**Subject:** Request for additional information regarding FCC ID: IHDT6GP1

Correspondence Reference Number: IHD0487  
Confirmation Number: 1608150486/488  
Date of Original Email: October 10, 2006

## 20 dB Bandwidth

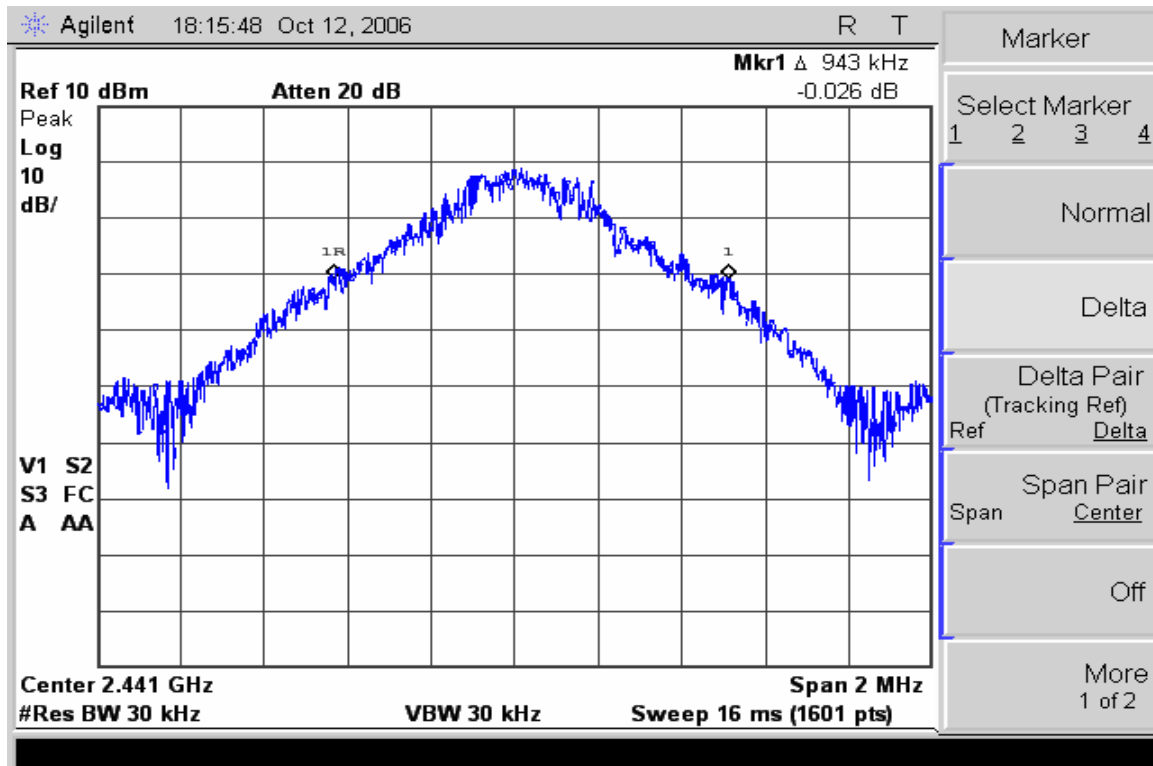
4. Please specify the detector function used to perform Part 24E spurious radiated and conducted measurements.

**Response:** Peak Detector
